### Federal Aviation Administration

[Docket No. FAA-2022-1647; Project Identifier AD-2022-01379-T; Amendment 39-22438; AD 2023-10-02]

### Airworthiness Directives; Transport and Commuter Category Airplanes

Final rule.

Figure 1 to paragraph (g)(1)(i)— *Fundamental Effective Isotropic PSD at Outside Interface of Airplane Antenna*

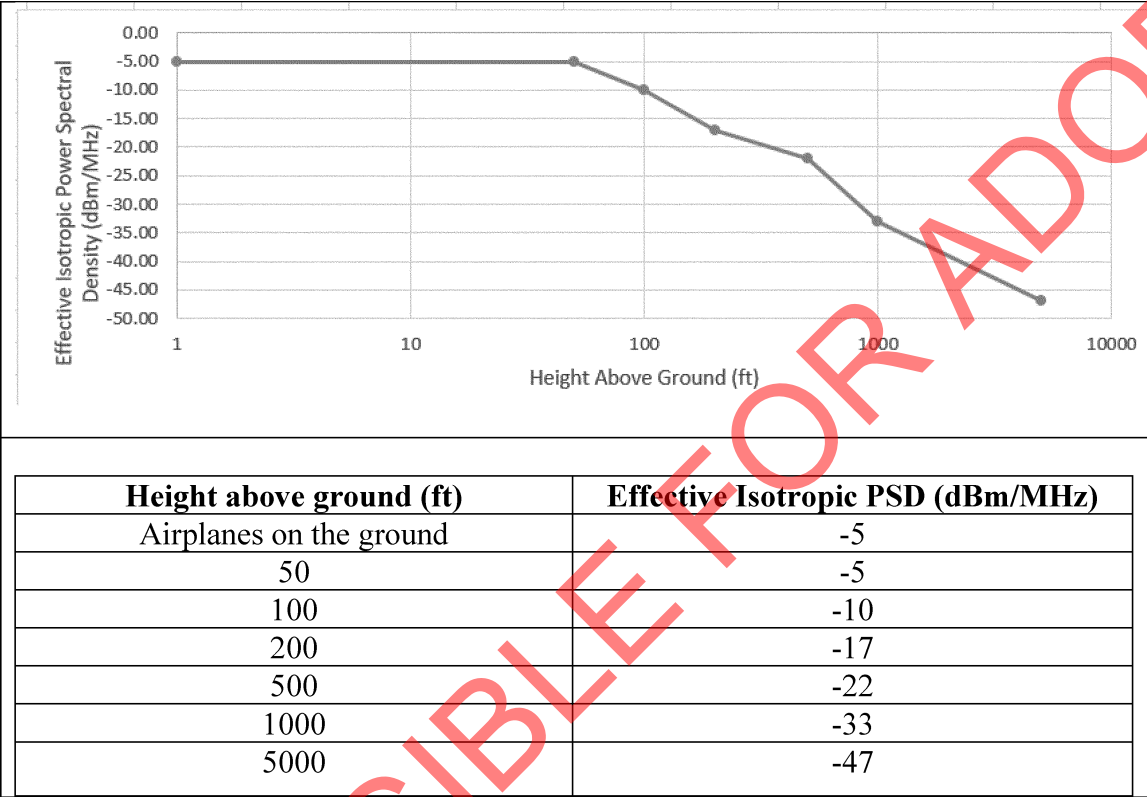
*Comment summary:* Textron Aviation requested the FAA clarify at what reference point the PSD requirements apply. The commenter stated it assumed that they apply at the radio altimeter receive antenna input, such that antenna characteristics, coax loss, and filter characteristics would be included in the determination.

*Comment summary:* Thales requested that the radio altimeter performance criteria specified in figure 1 to paragraph (g)(2) of the proposed AD be revised to explicitly cover any 5G emitter station up to 65 dB/MHz in the applicable 3.7–3.98 GHz band.

*FAA response:* The FAA agrees and has changed the title of figure 1 to paragraph (g)(1)(i) of this AD to reflect that the PSD requirements apply at the antenna input to the radio altimeter, and that the figure applies to the outward facing side of the antenna.

*FAA response:* The FAA agrees and has changed paragraphs (g)(1)(i) and (ii) of this AD to include the applicable frequency bands.

Figure 2 to paragraph (g)(1)(ii)— *Spurious Effective Isotropic PSD at Outside Interface of Airplane Antenna*

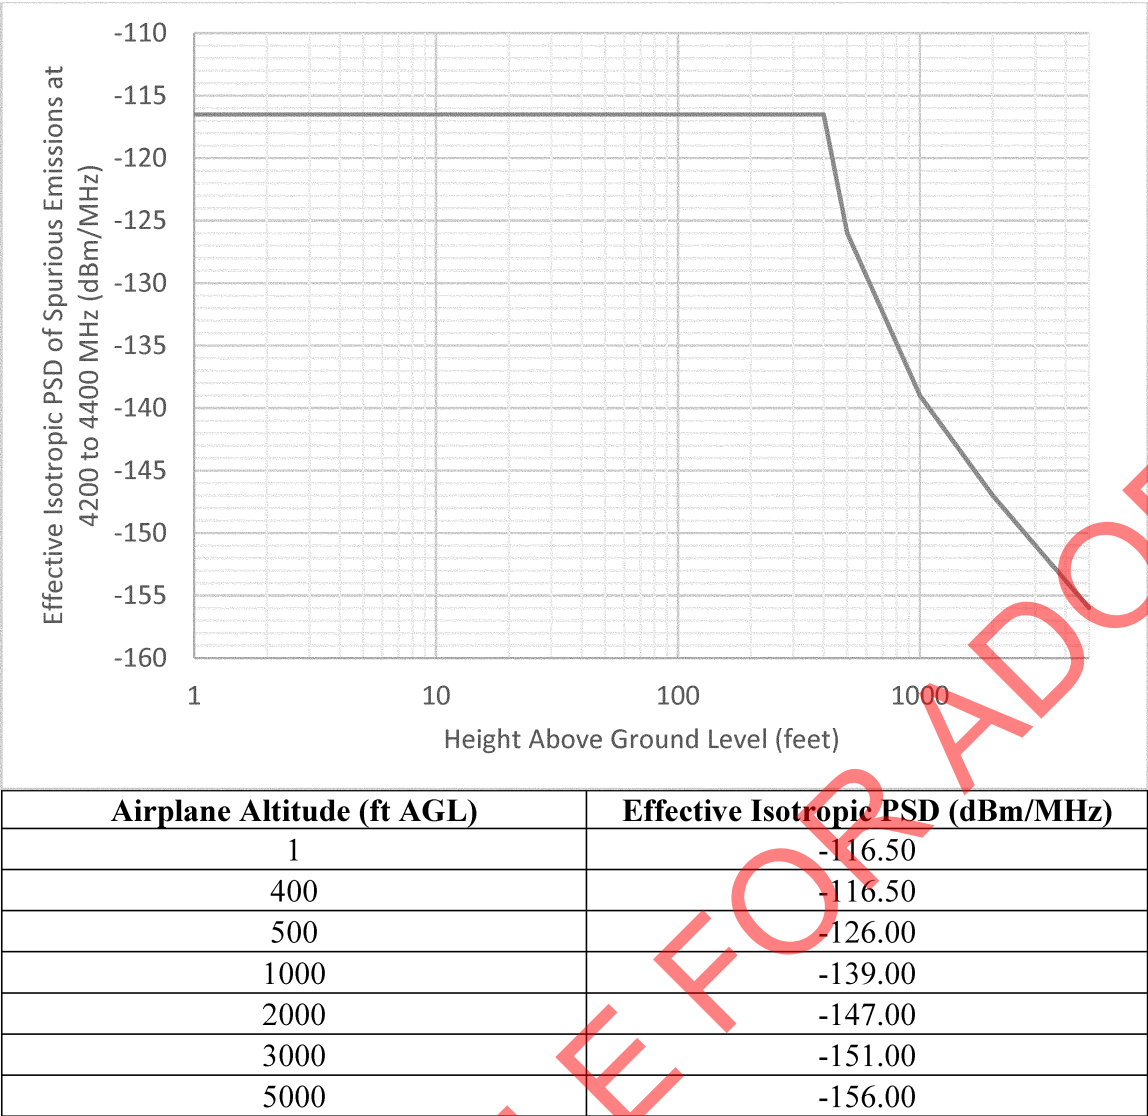
*Comment summary:* AIA requested that the FAA provide more information about the tolerances for determination of whether an airplane is radio altimeter tolerant. Several commenters requested that the FAA add a new figure indicating the spurious tolerance, similar to the figure with the PSD tolerance curve, and a specification of the altitude dependence for spurious tolerance.

*Comment summary:* Airbus and Bombardier requested that the FAA revise the table at the bottom of the proposed PSD curve to add the limit for 2500 feet above ground level. The commenters stated that

this would be consistent with the maximum operating range of popular radio altimeter models installed on many airplanes and would avoid extrapolation errors.

*FAA response:* The FAA agrees and has replaced the proposed fixed emission level with a spurious PSD tolerance curve in figure 2 to paragraph (g)(1)(ii) of this AD. Subsequent figures have been redesignated accordingly.

*FAA response:* The FAA disagrees. The FAA developed the PSD curve to cover all transport and commuter radio altimeters and has determined that any extrapolation errors are sufficiently small and will not affect compliance or compromise safety.
